**Final  
Report on an Investigation of  
Peoples Gas Pipeline Safety Program**

**Illinois Commerce Commission**

**August 14, 2008**

**c. Main Leaks Caused by Excavation Damage**

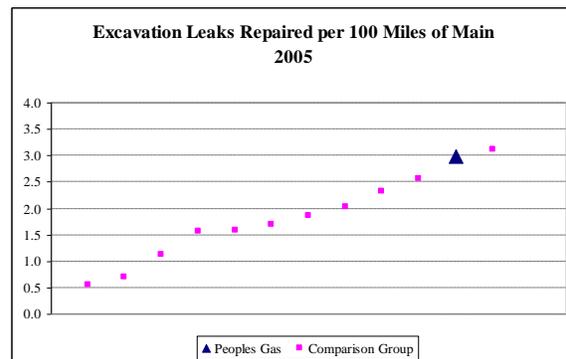
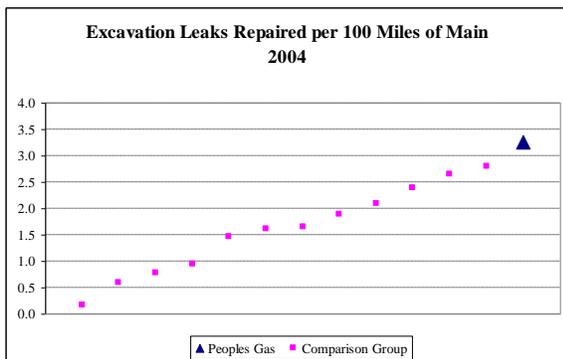
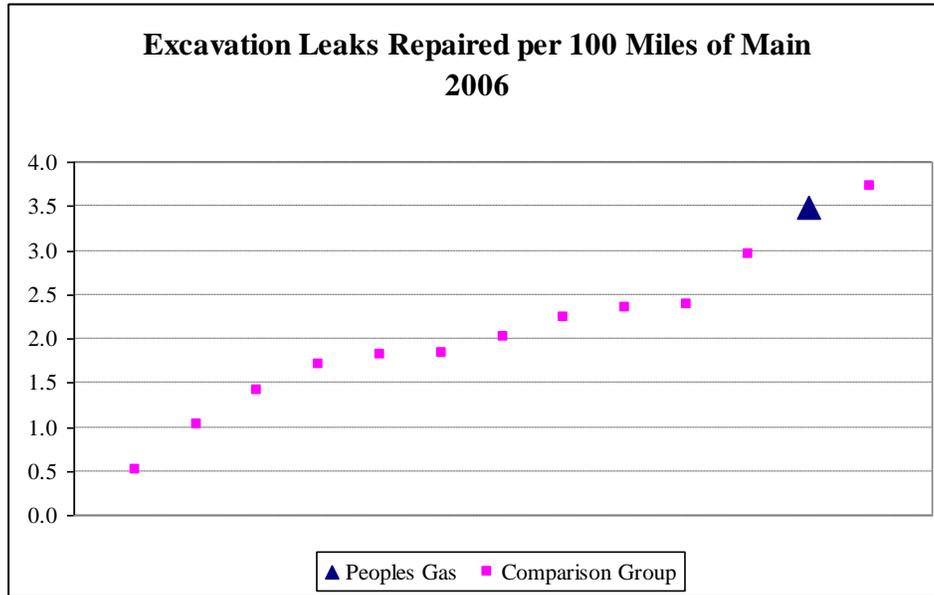
Peoples Gas' excavation-damage-prevention performance ranks poorly relative to the peer group. Its damage rate to mains resulting from excavation is in the highest risk sector of its peer companies, an indication of poor damage prevention performance.

**d. Services Leaks Other Than Caused by Excavation Damage**

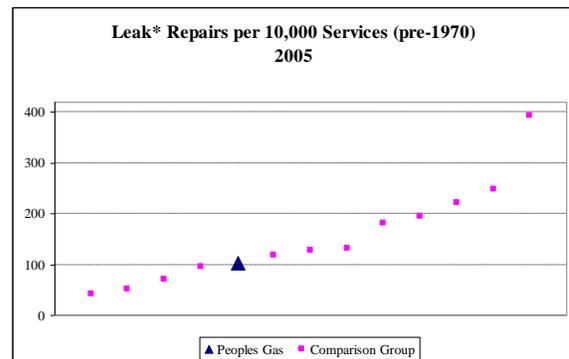
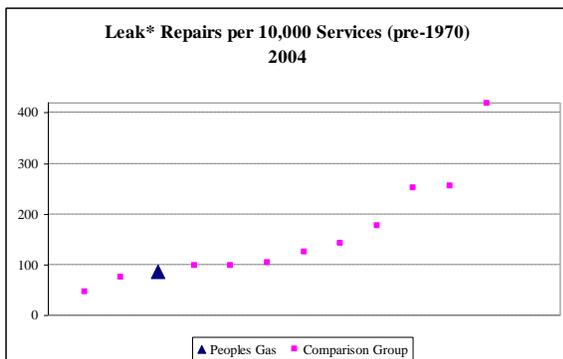
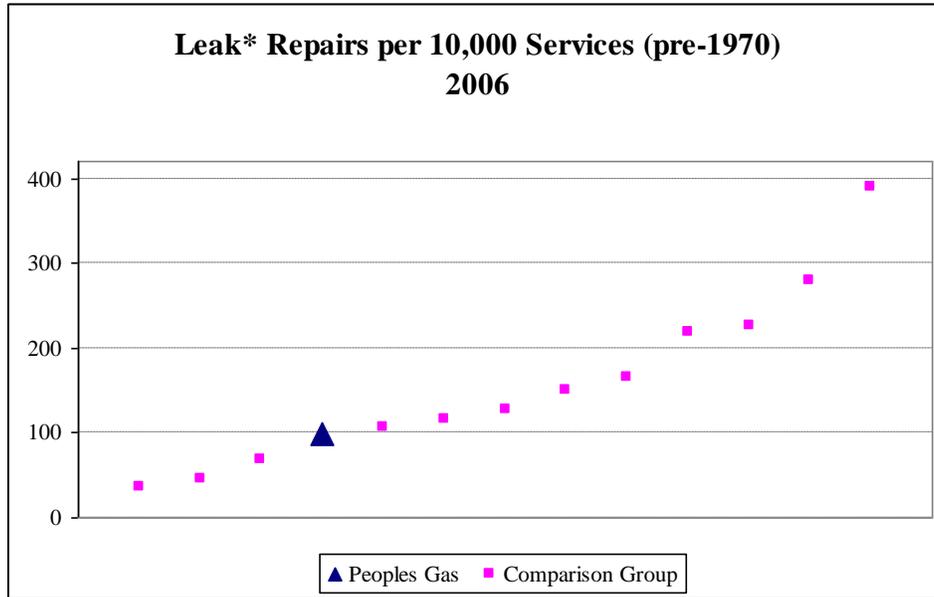
These charts appear to place Peoples Gas in a favorable performance risk sector. The lower rate of leaks experienced implies better material performance than the peer group. However, Peoples Gas may artificially depress this number by not repairing service line leaks in a timely fashion. Therefore, this metric also needs to be reviewed in the context of the leak repair backlog.

**e. Services Leaks Caused by Excavation Damage**

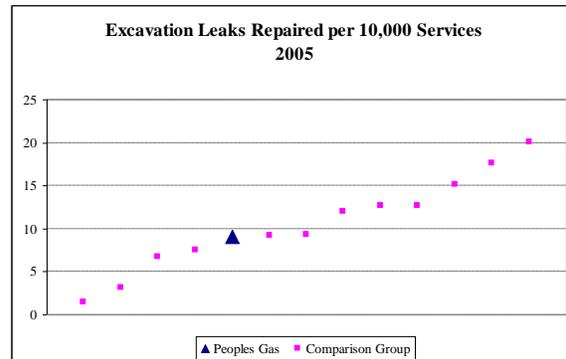
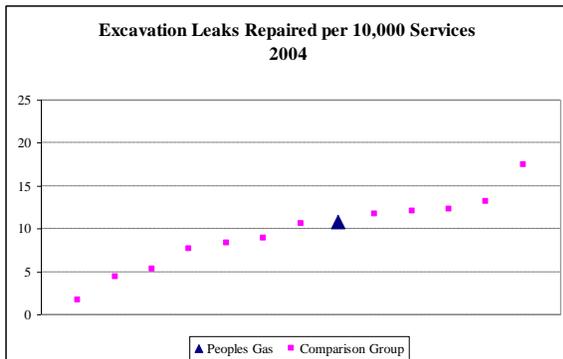
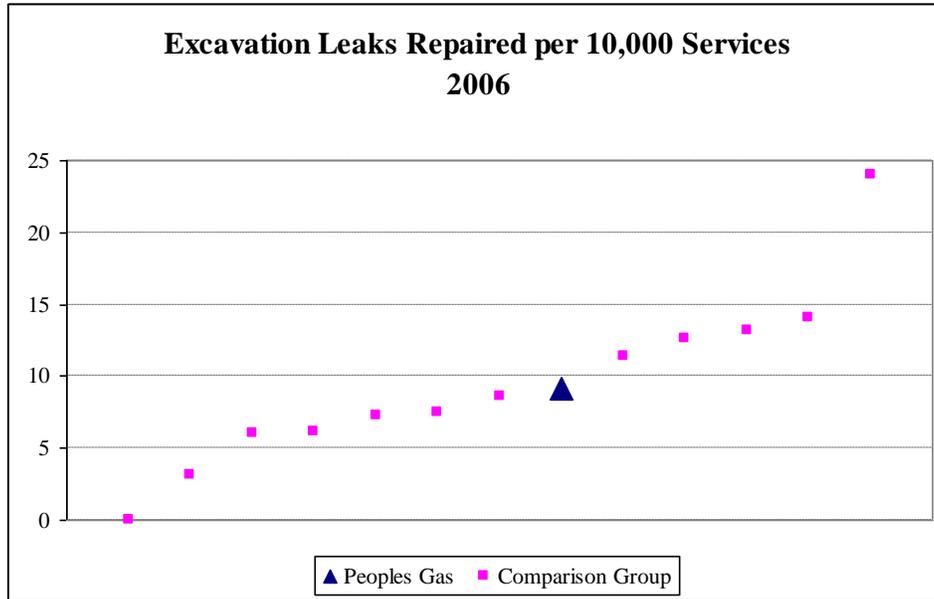
Peoples Gas' service line leak repair rate from excavation damage is slightly higher than the peer group average. Peoples Gas' damage rate to its service lines places it in the higher than average risk sector. This metric, taken together with PGL's excavation damage rate per 100 miles of main is unacceptable, presenting a high risk to the public.

**f. Leak Backlog**

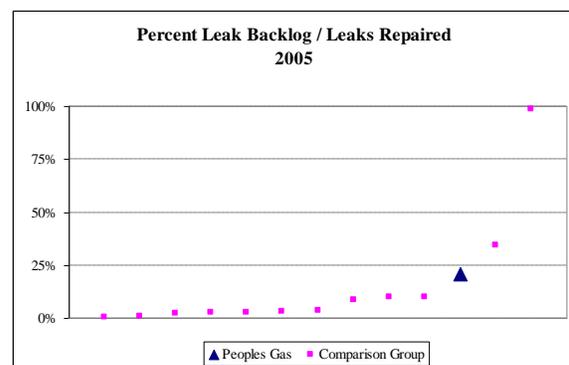
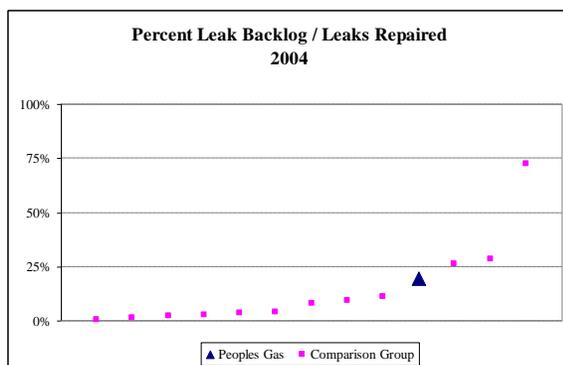
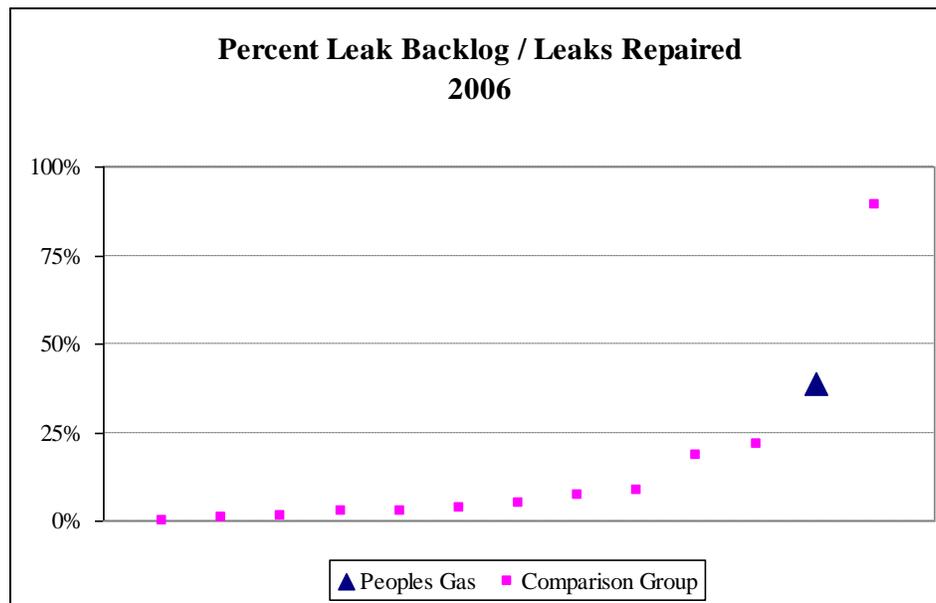
The percent leak backlog per leaks repaired metric is a direct reflection of the risk posed to the public by allowing leaks to go unrepaired at year-end, a time when frost enters the ground and provides a greater risk of leaking gas migrating into habitable structures. Good operators reduce their leak backlog levels prior to frost conditions.

Peoples Gas’ leak backlog performance presents an unacceptably high risk. To increase safety, Peoples Gas needs to reduce its backlog of leaks, *i.e.*, repair more leaks.

**g. Lost and Unaccounted for Gas**

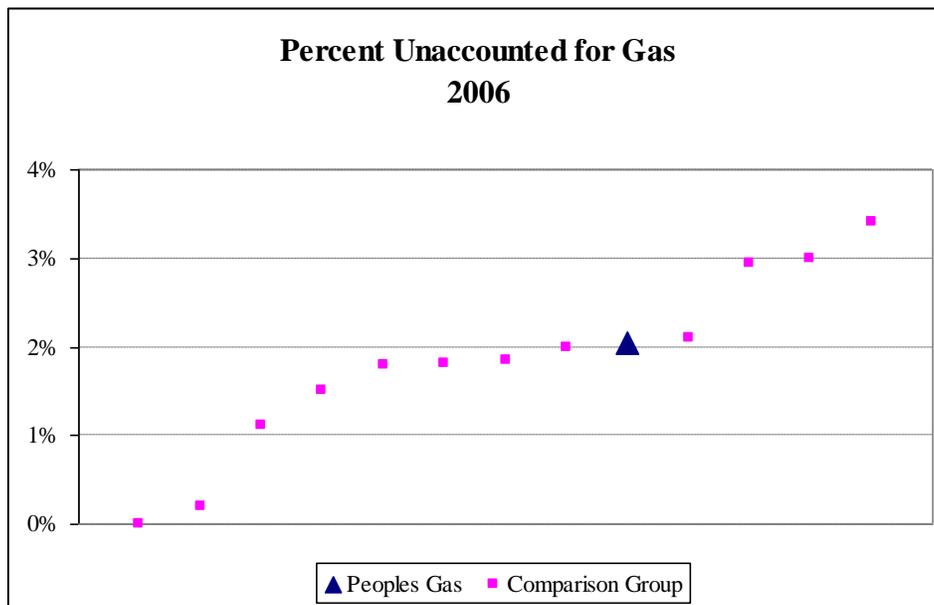
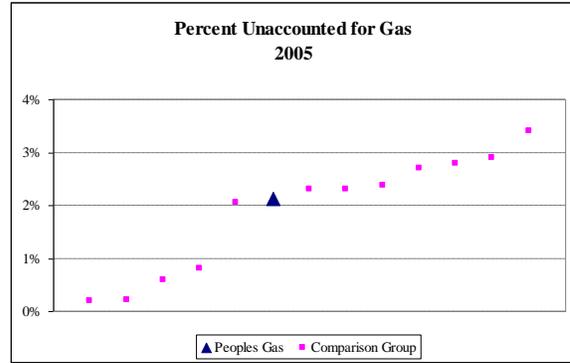
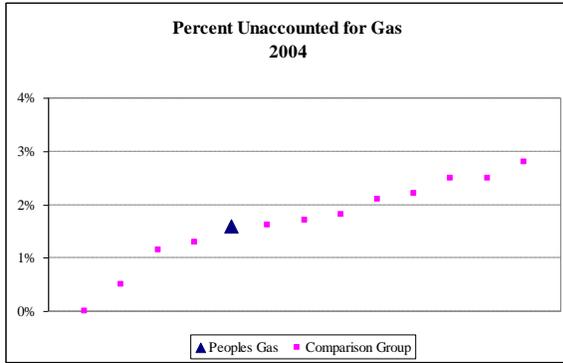
Peoples Gas' reported level of lost and unaccounted for gas has remained at about 2 percent and is average for the peer group.
